To: Kristopher Byrd, Well Construction and Compliance Section Manager
From: Travis Kelly, Well Construction Program Coordinator
Subject: Review of Water Right Application G-18254
Date: September 30, 2021

PUBLIC INTEREST REVIEW FOR GROUNDWATER APPLICATIONS

SUBJECT: Application G- 18254 Supersedes review of _____
Date of Review(s)

_____**Water-Level Trends in Nearby Wells**

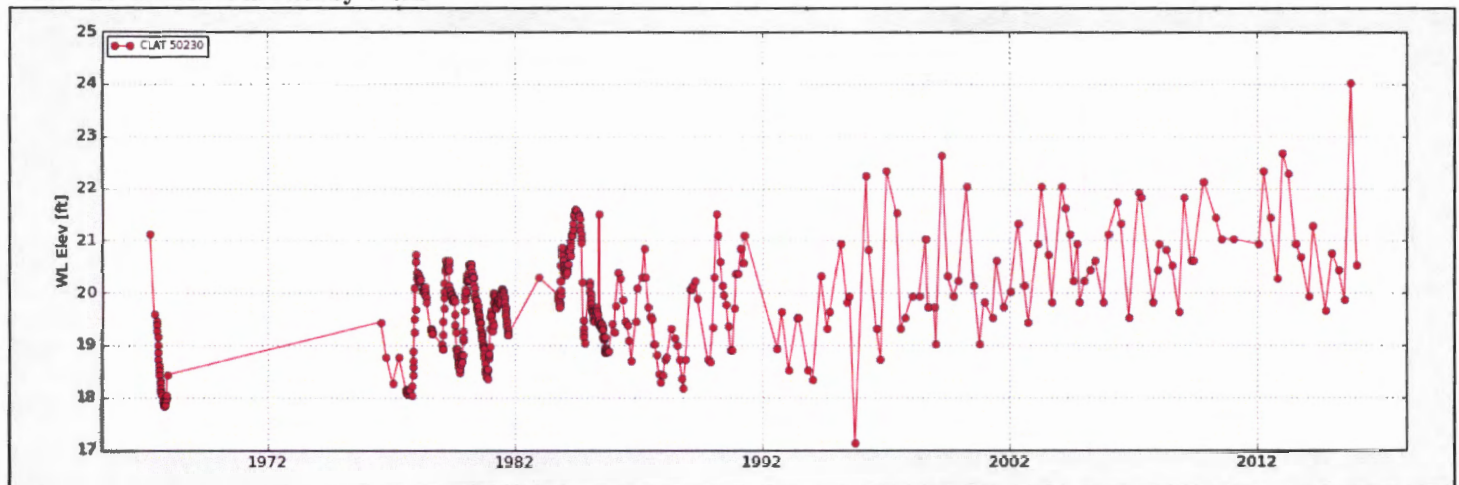
- B3. **Groundwater availability remarks:** The applicant's well will be producing from dunal sand deposits along the Pacific Coast. OWRD has SWL data from a few wells that are < 3 miles south of the proposed POA and which show stable water levels over the past several decades. Furthermore there are no permitted groundwater rights within 2 miles of the proposed POA except one for permit G 15354 which has the same well as the one proposed on this application (CLAT 51645) so injury should not be an issue.
- _____
- _____
- _____
